Date & Time: Monday, March 21, 2016 (9:30 a.m.)

Location: Truax Lab, Antigo Silt Conference Room – Madison, WI

Bridge Technical Committee Structures Design & Construction Subcommittee

March 21, 2016

Concrete Overlays at Exp. Joints

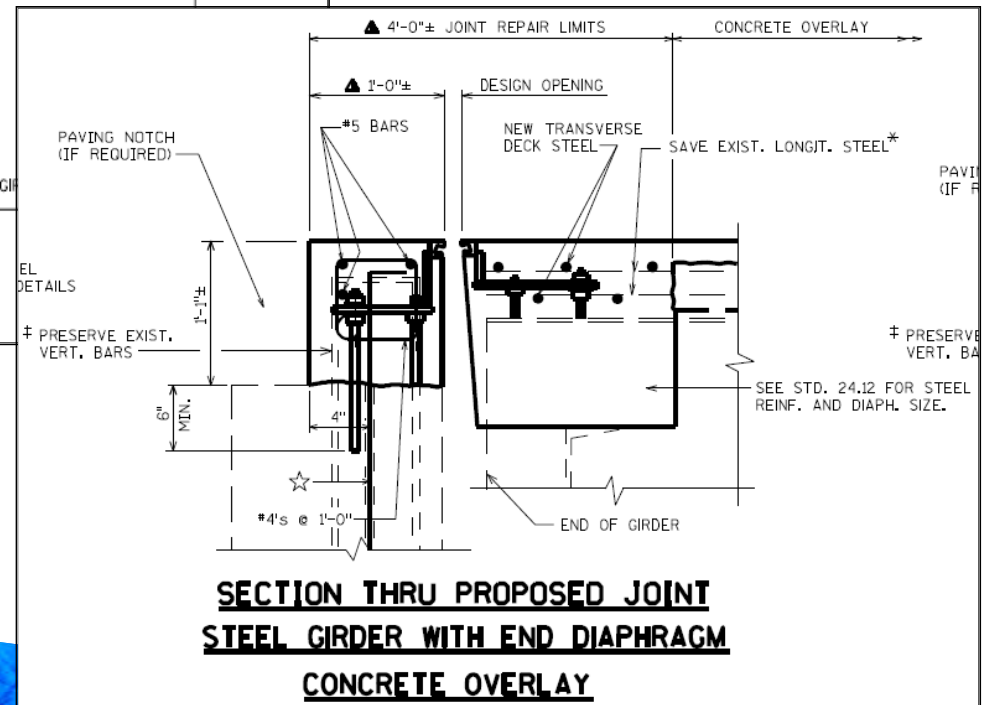
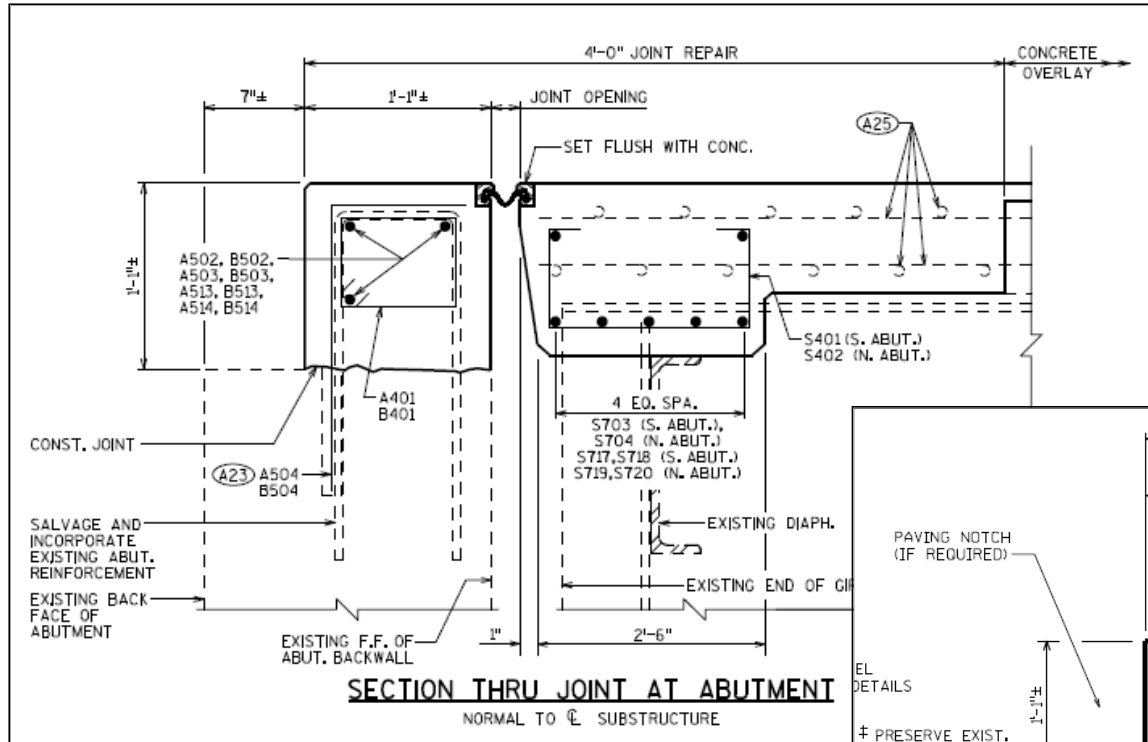
1.11	3/21/16	Concrete Overlays at Expansion Joints	Open	7/2016	WisDOT/WTBA
		<p>Standard plan detailing calls for a full-depth paving block and end diaphragm pour to be done monolithically with the concrete overlay. Historically this detail has not been constructed this way – industry has held the paving block and end diaphragm pours down to the bottom of the overlay elevation and comes through with paving equipment to pour the overlay over the joint. BOS’s concern is for the long-term maintenance of the paving block to resist spalling. Industry’s concern is with getting a satisfactory ride quality on both sides of the joint. <i>Industry will follow up to determine exactly why the current detail can’t be followed, particularly why the paving blocks at both ends can’t be poured full-depth. BOS will review the detail and potentially allow for the contractor to pour the end diaphragm prior to pouring the concrete overlay on the deck side of the joint (i.e., optional construction joint below the overlay on the deck side). Any updates will come in the form of Standard detail updates in the next update to the Bridge Manual.</i></p> <p>2016-03-21: David Stanke discussed Zenith Tech’s approach to constructing these bridge elements with BOS at the Bridge Tech Committee meeting. David indicated that the paving block located on the side of the bridge where the paving machine starts the overlay pour</p>

- ▶ Historical detailing practices show that paving block and end diaphragm are to be poured monolithically up to the top of overlay elevation
- ▶ Historical construction practice has been to pour paving block and end diaphragm to bottom of overlay, and follow-up with overlay over the length of bridge including the paving block

Anchor Bolts & Substructure Reinf. Conflicts

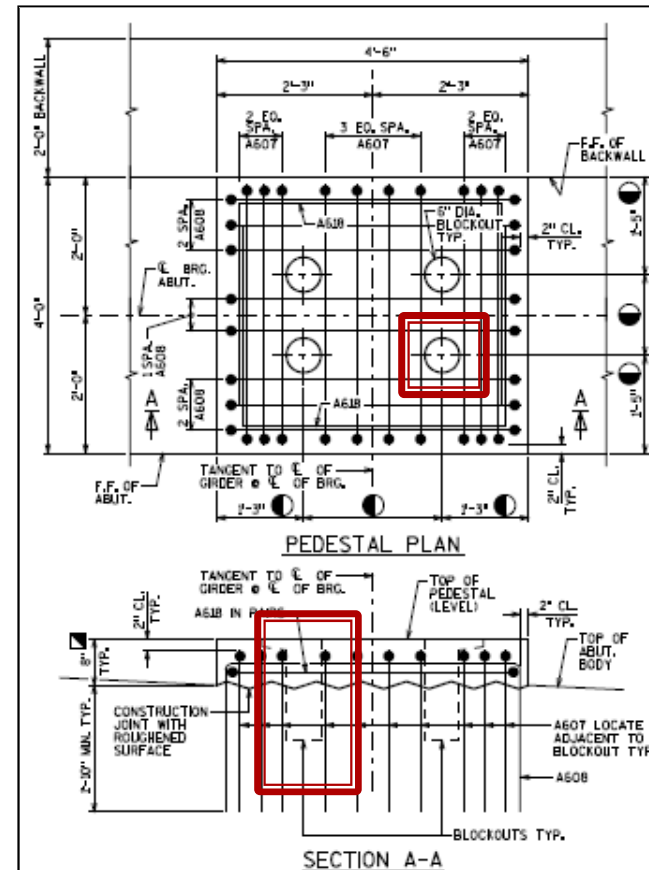
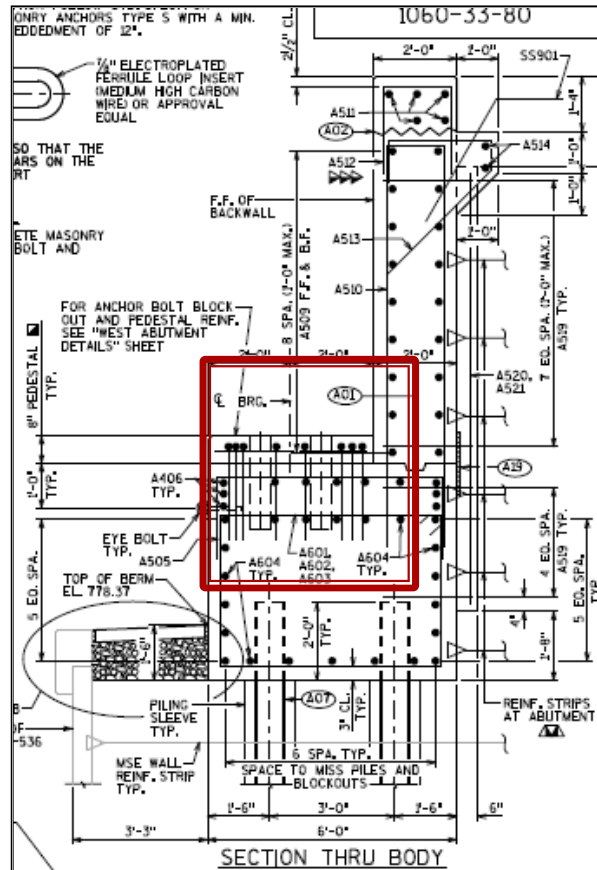
Contractors routinely encounter reinforcing steel in substructures when drilling for bearing anchor bolts. Designers should account for potential conflicts by bundling bar steel, utilizing or allowing for embedded blackout cans (in certain situations only as they are difficult to use in the field for industry), and providing allowable clearance details in the plans for clarification. WTBA recommended that a minimum of 4" clear for anchor bolts be used as guidance. WTBA also recommended that as much clear space as possible (5" to 6") be provided to allow for vibrating equipment, flow of concrete, etc. Zenith Tech stated that they utilized coped flanges on prestressed girders to allow for easier flow of concrete at diaphragm locations. *BOS will provide guidance to in-house and consultant designers with clearance recommendations and potential coped girder flange standard detailing in future updates to the Bridge Manual, and will mention both items at the June 2016 Structural Engineers Symposium.*

- ▶ Contractors drilling into conflicting substructure reinforcement when trying to install anchor bolts for girder bearings
- ▶ Construction possibilities (may be done already)
 - Anchor bolt templates while tying rebar cages
 - RFI to designer to bundle reinforcing steel
 - Other ideas?

- ▶ One potential option in design – ANCHOR BOLT BLOCKOUTS

Anchor Bolts & Substructure Reinf. Conflicts

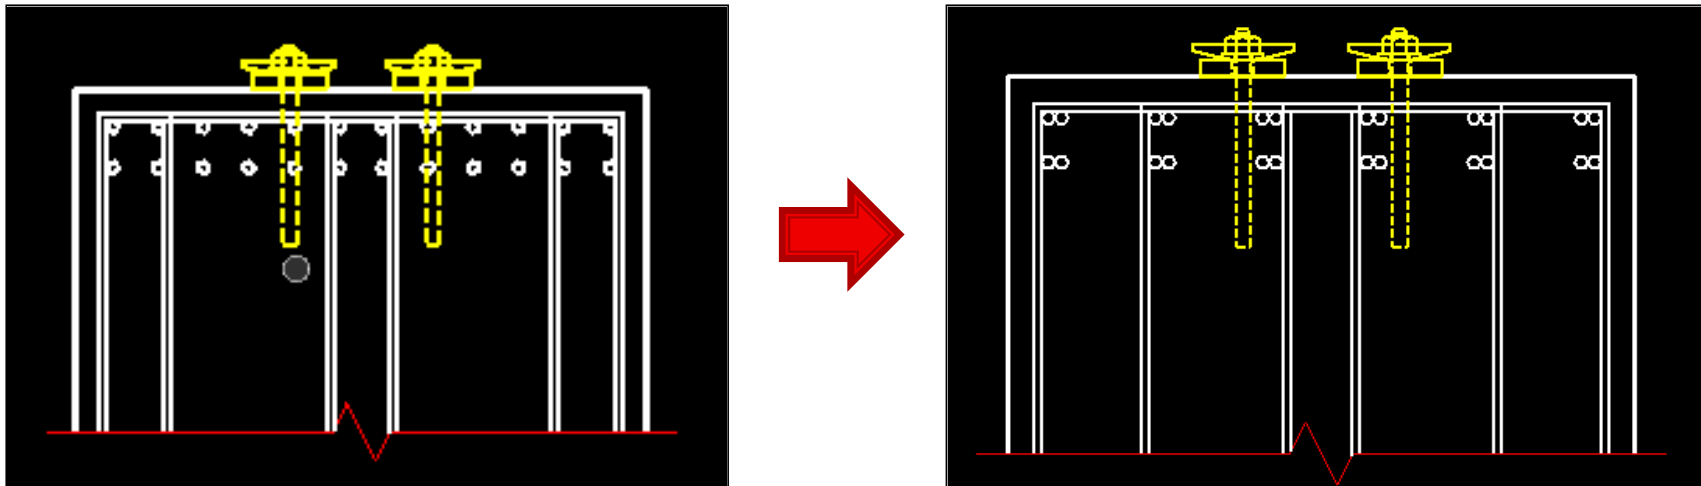
- ▶ Another potential option in design – BUNDLING BARS

- ▶ Better design and planning in the field should be able to limit this issue – especially on new structures
- ▶ If conflicts are encountered in the field, inquire with BOS for potential fixes/solutions

Parapet Steel on Pedestrian Bridges

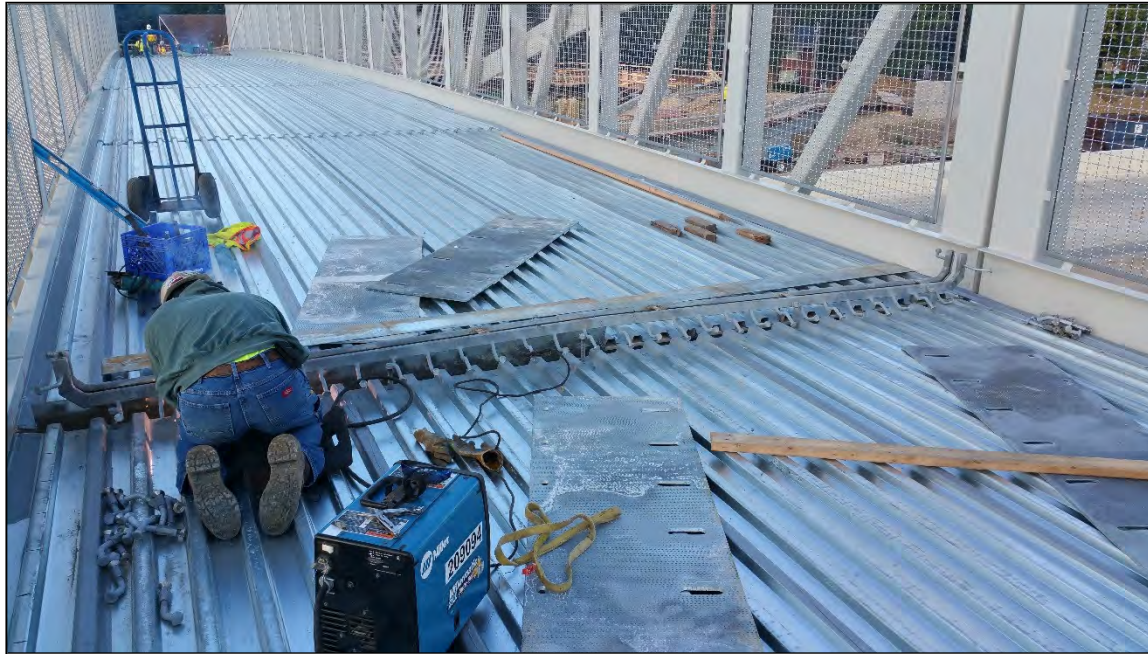
Industry has expressed concerns that vertical face parapet bar steel extending out of deck causes issues with paving equipment during the deck pour. This is also an issue at wing locations. *BOS is currently working on updated Standard parapet reinforcing steel detailing and will provide guidance through the next update to the Bridge Manual.*

- ▶ Need for different paving equipment on pedestrian bridges to get above embedded parapet bar steel?
- ▶ BOS is working on new standard details for “shorter” cast-in bar protrusions (anticipated completion: July Bridge Manual update)
